ADDENDUM NO. 2

RE: Contract No. AP-PG-18-084 - Airport Parking Lot Pay System

CONTRACT NO. AP-PG-18-084
AIRPORT PARKING LOT PAY SYSTEM

**HAGERSTOWN REGIONAL AIRPORT
 RICHARD A. HENSON FIELD
 TERMINAL PARKING LOT
 MODIFICATIONS - PHASE 1A**

PARKING LOT PLAN
Scale: 1" = 50'

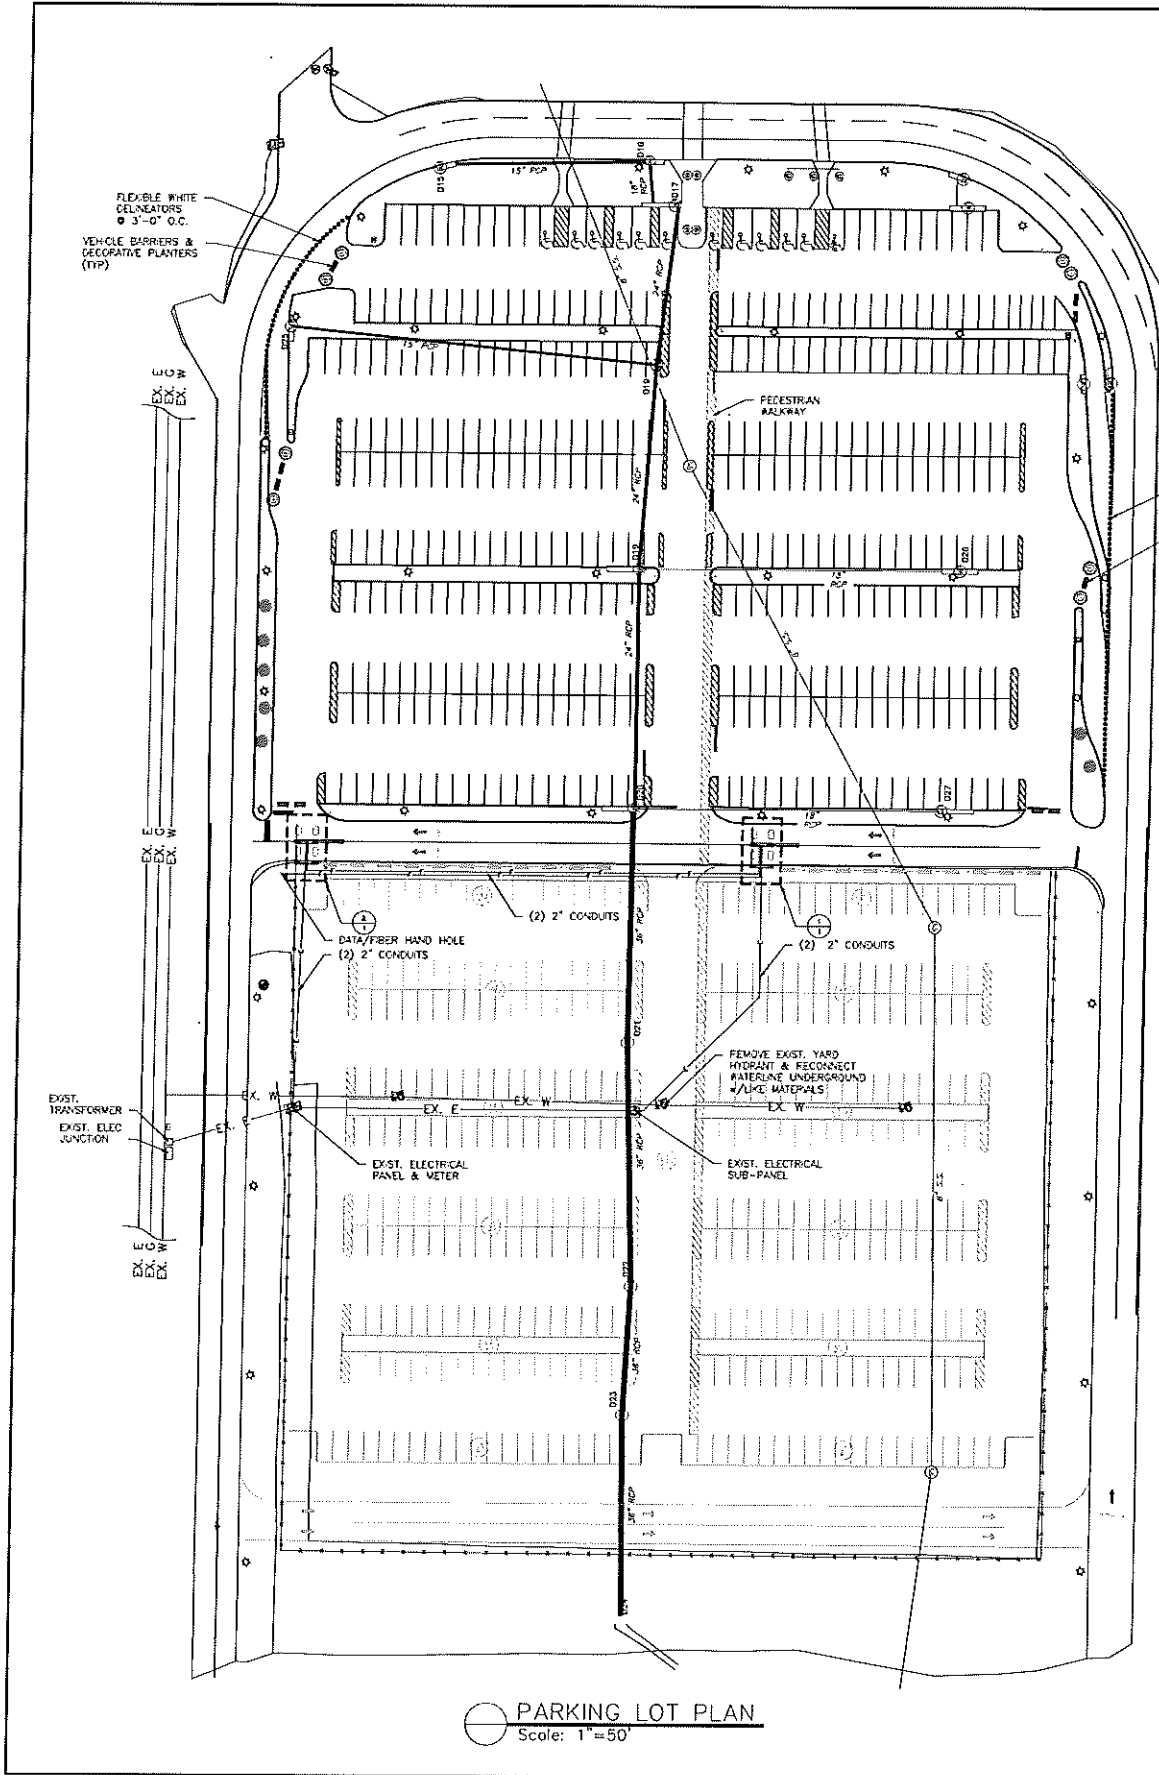
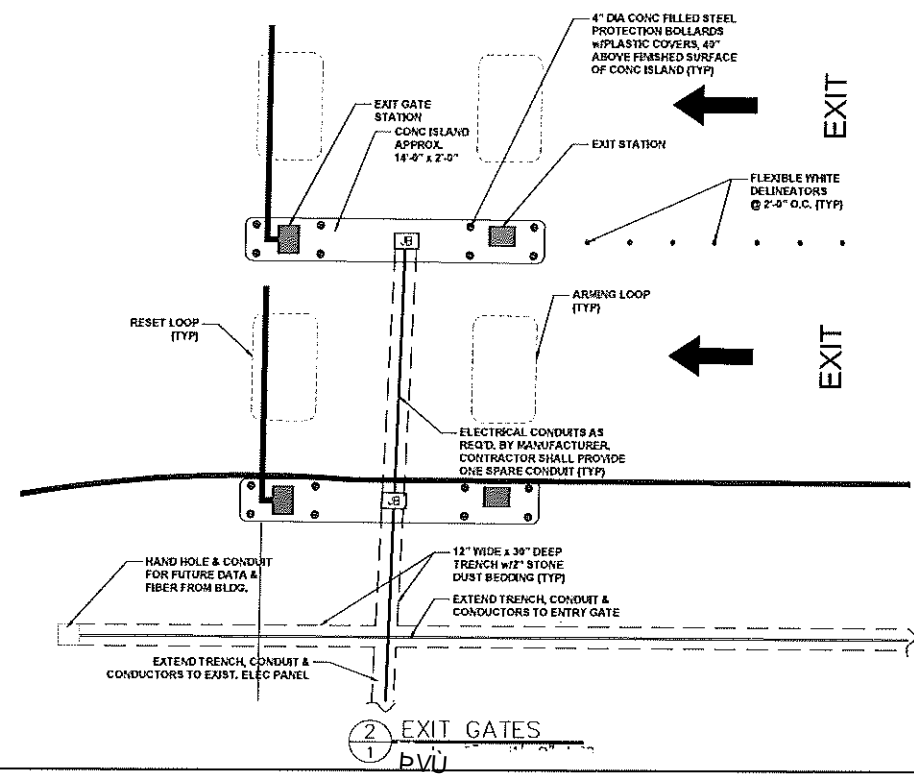
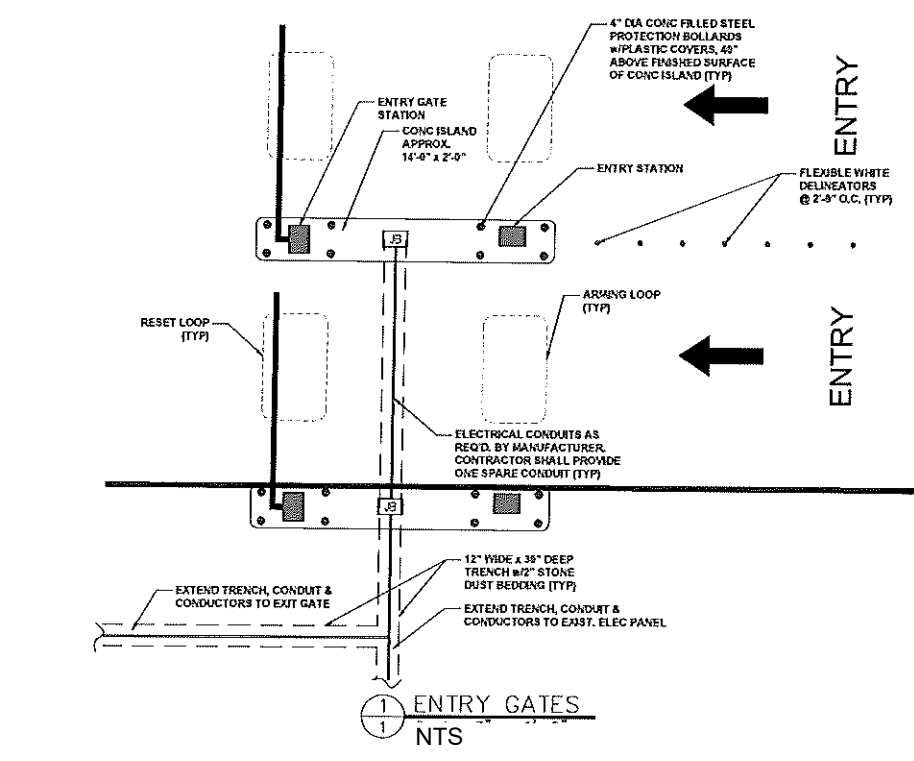
Question 23: Drawings show white flexible delineators by entry and exit lanes as well as throughout the parking lot. Can you confirm who is providing all of these and if vendor (quantity desired)

Question 24: 32 Concrete Filled Bollards at entry/exit lanes – will contractor doing the islands be providing those (during island work – concrete) or will vendor be responsible for this? If vendor, do you desire surface mount bollards (concrete filled) or are they to be recessed into the concrete

Question 25: Conduit – can you confirm an empty data conduit (with pullstring) will be installed for this project between the entry and exit plazas (interconnect all lanes)

Response: Washington County will provide and install all flexible delineators.

Response: Washington County will provide and install the concrete filled bollards.

Response: Yes, an underground conduit for data (with pull strings) will be provided between the entry and exit gate locations.
